Addendum No. 3
Page 1 of 7

TO: Prospective Bidders
SUBJECT: Addendum No. 3
PROJECT NAME: City Center Campus Audio Visual Equipment
JJC PROJECT NO.: B16016

1 AUDIOVISUAL RACK ELEVATIONS
NTS

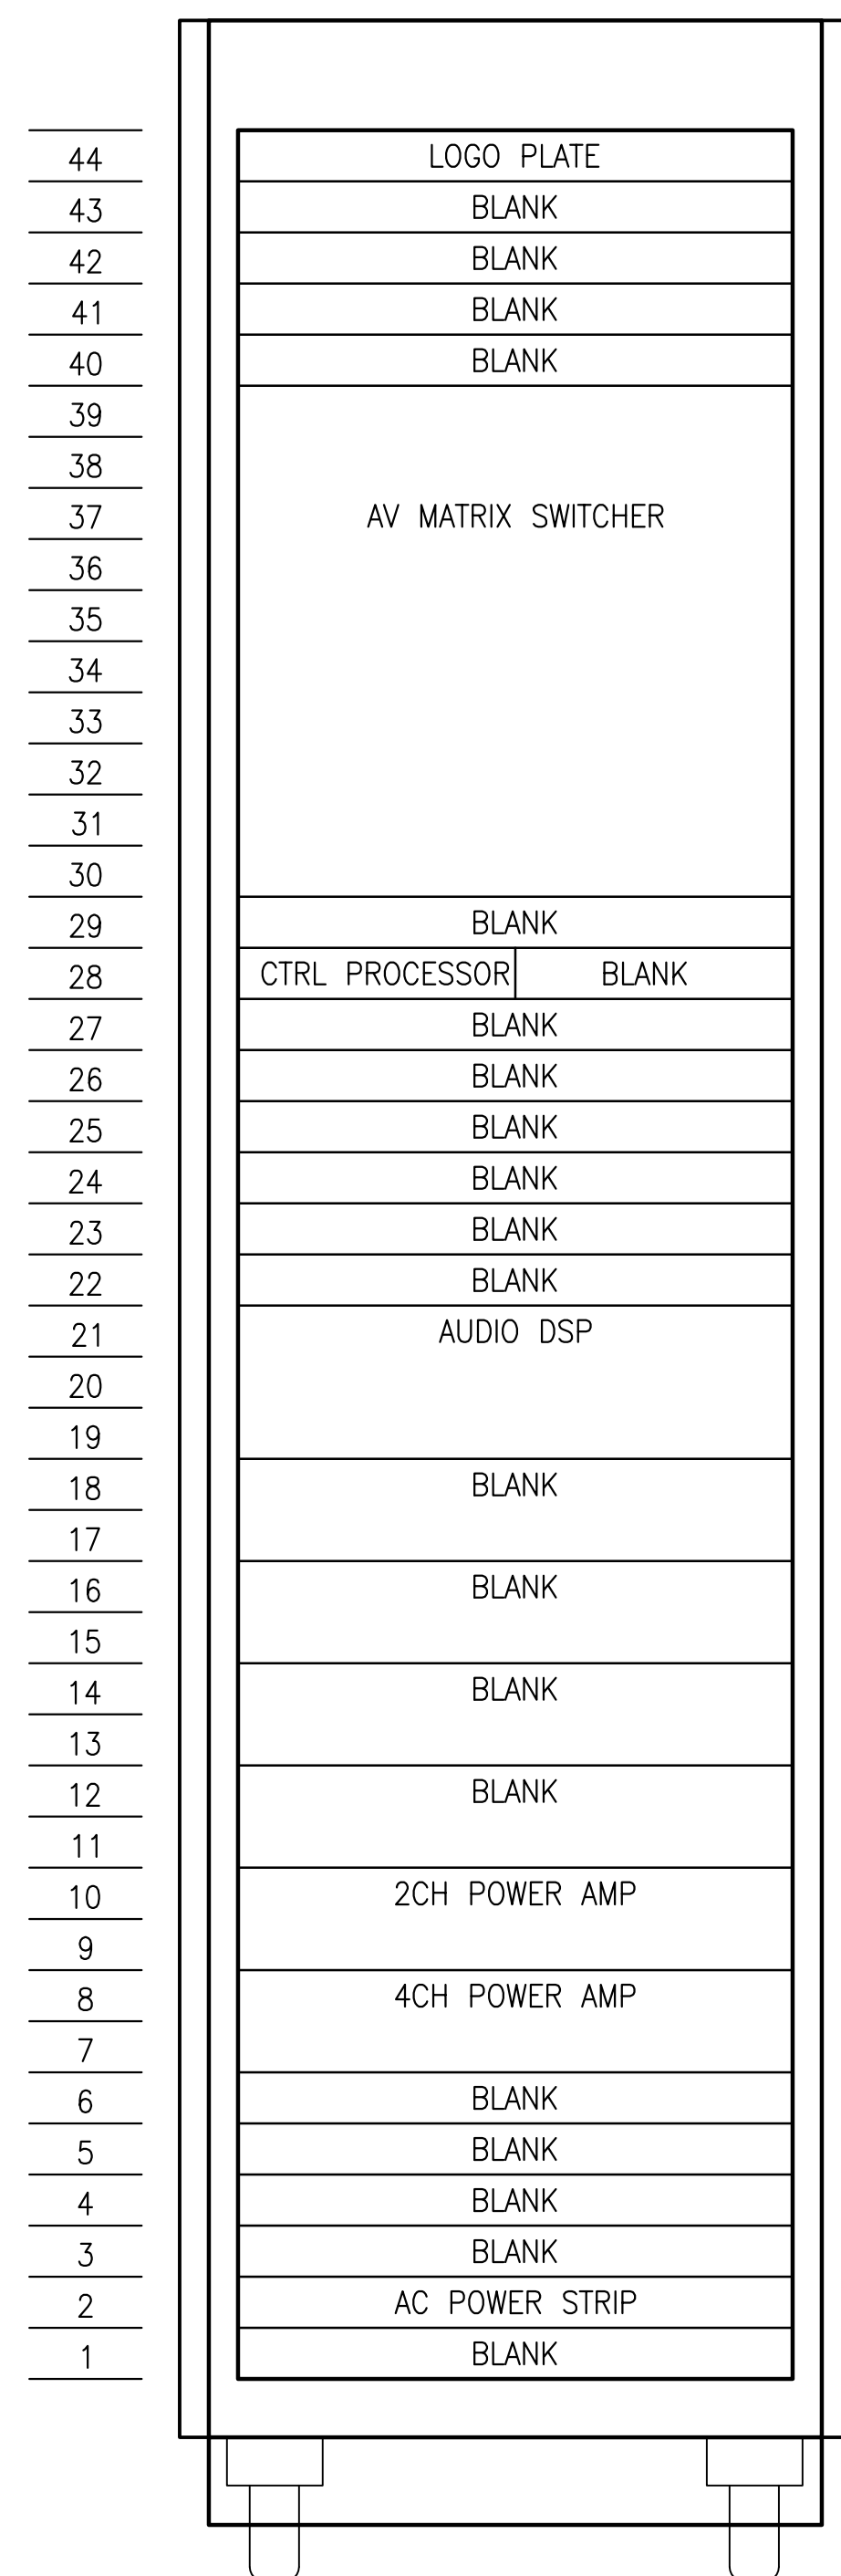
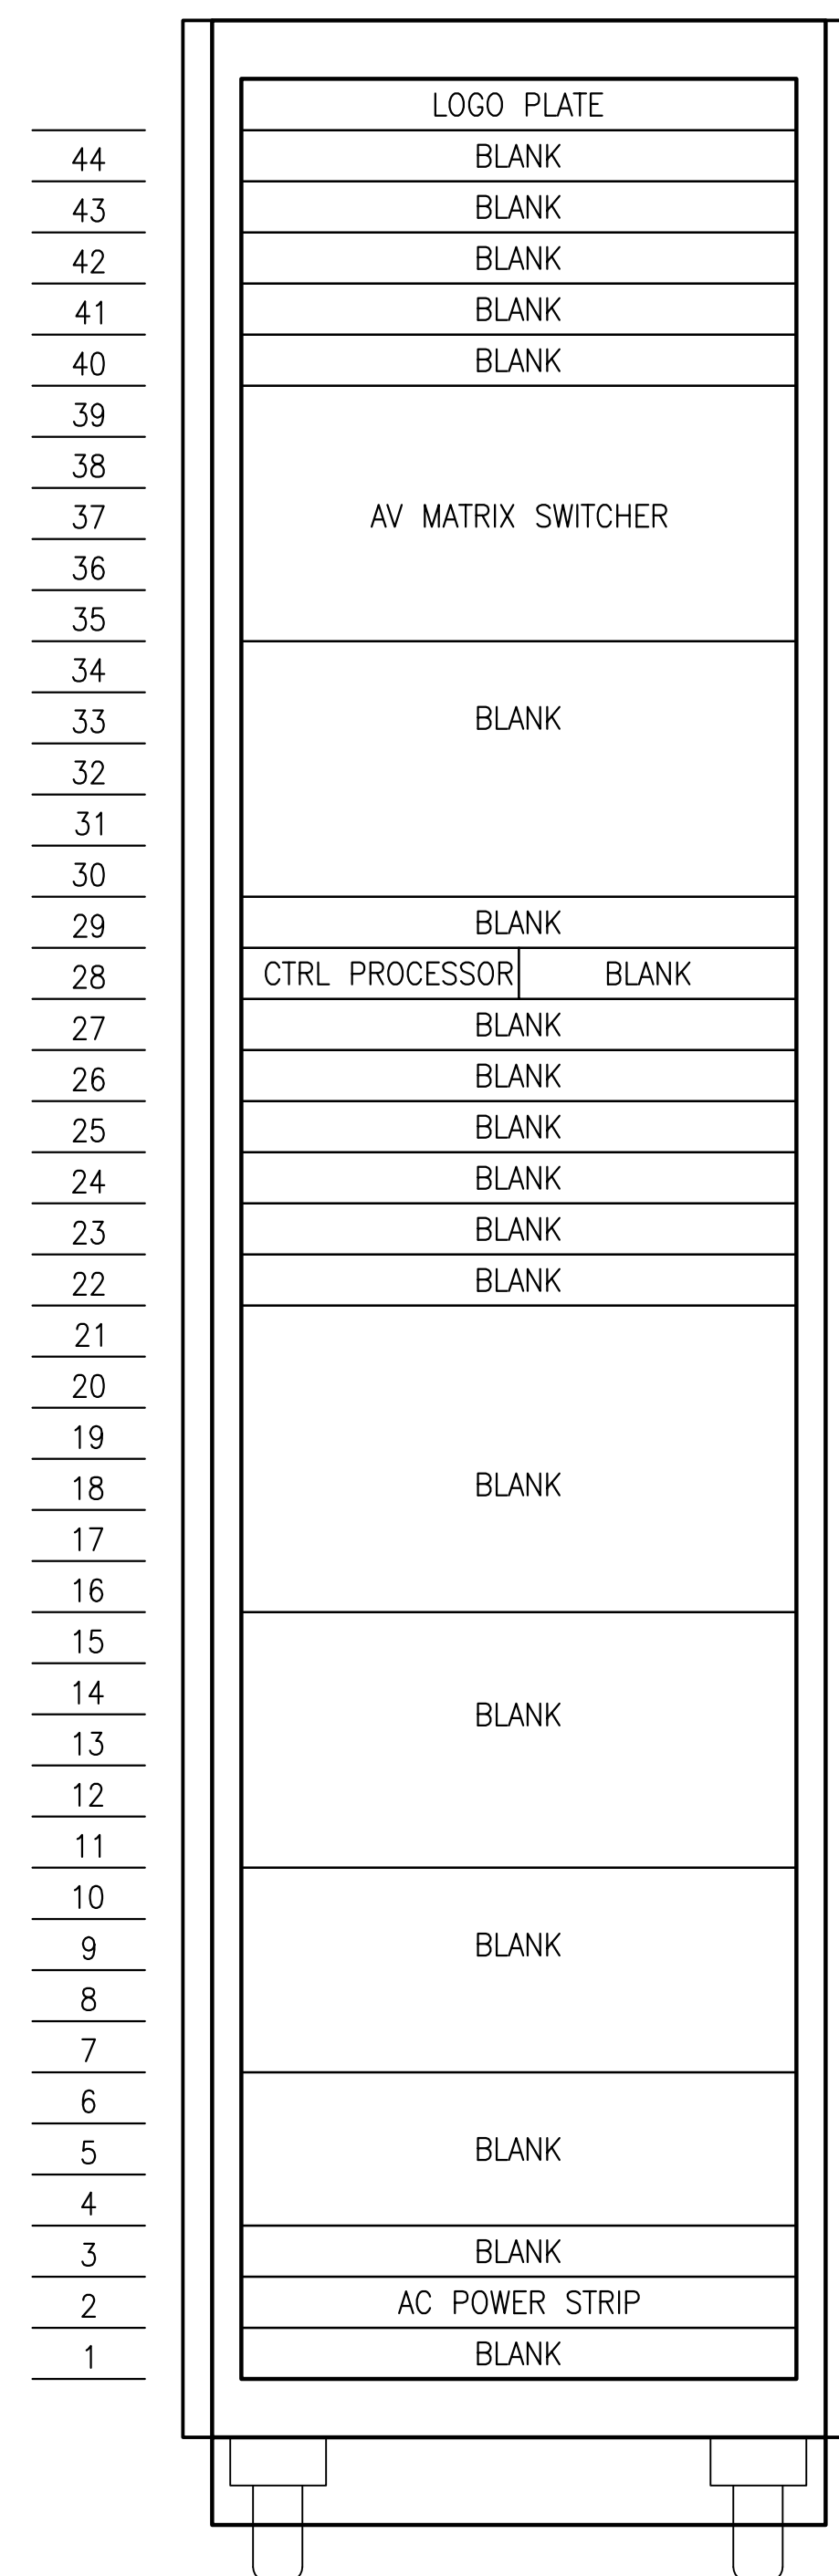
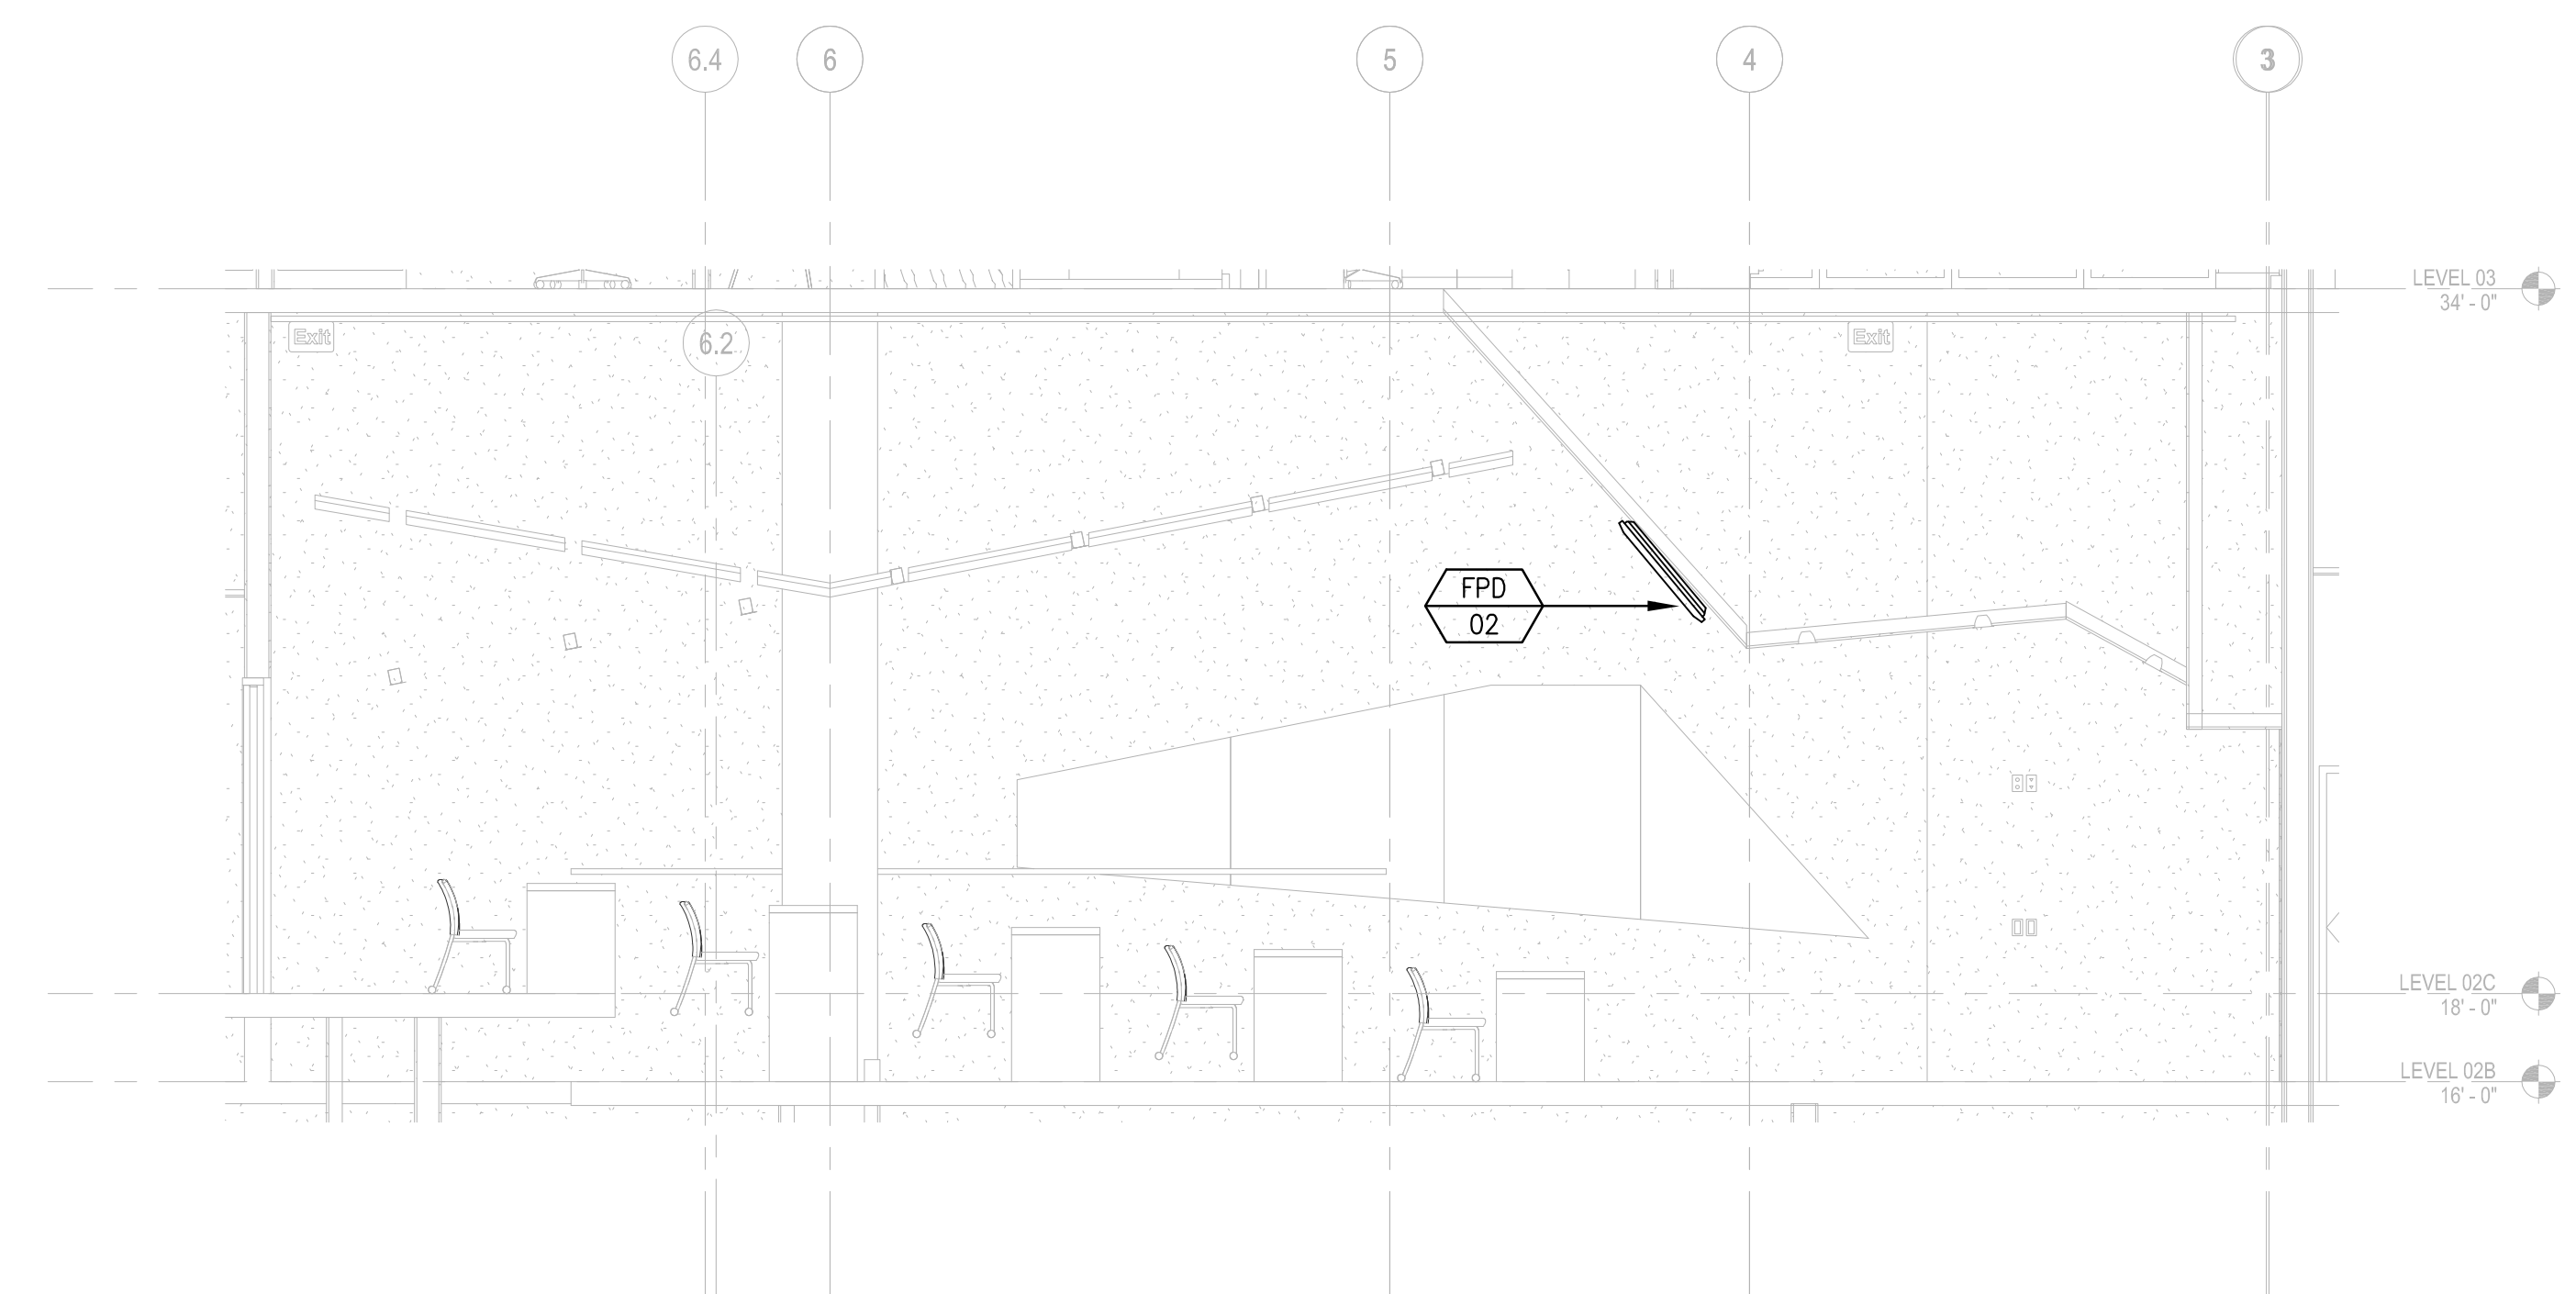
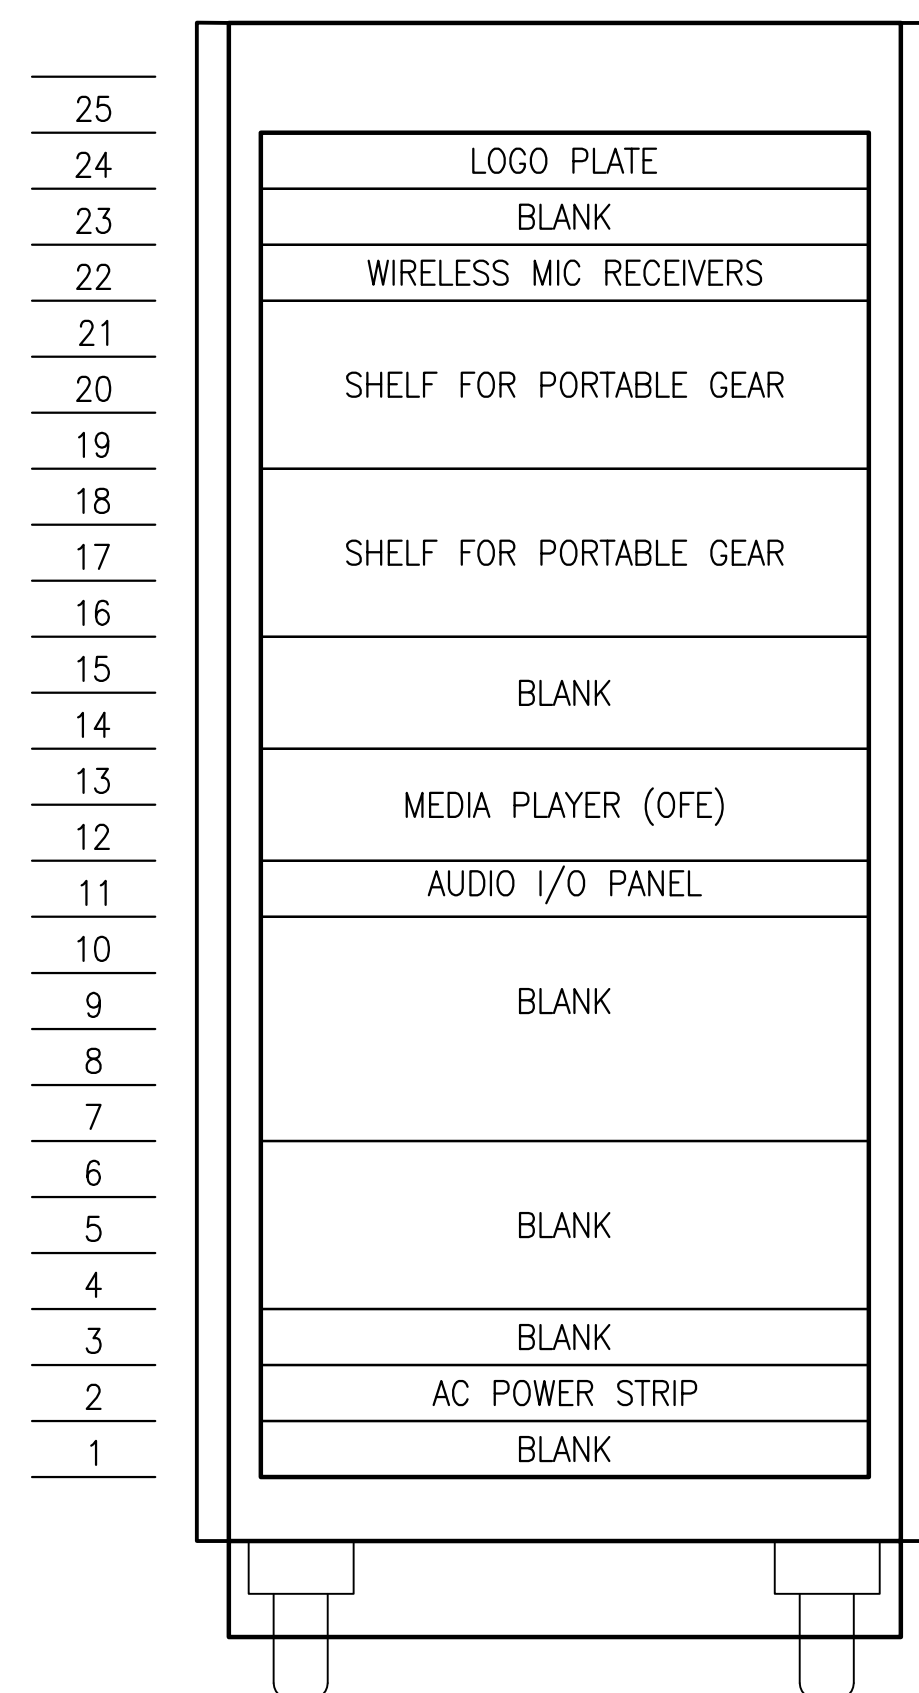
2. Sheet TA-900: Add attached sheet. This sheet includes the replacement AV rack layouts, as well as a section drawing of Room 2003, showing the installation location of the 55" Flat Panel Displays (Qty 2). Each of the two displays should be installed equidistant between the room lengthwise center line and one of each of the two side walls.

3. ***Please note that the AV equipment rack layouts on TA-900 show the smaller 16x16 AV Matrix Switcher in the 5th floor AV rack. This is to indicate that the AV integrator has the option of locating this matrix switcher on the 5th floor. This may be required should the AV integrator determine that field conditions are such that the CAT6A FTP cable runs will exceed the limit for digital AV over IP. The signal flow drawings remain as is.***
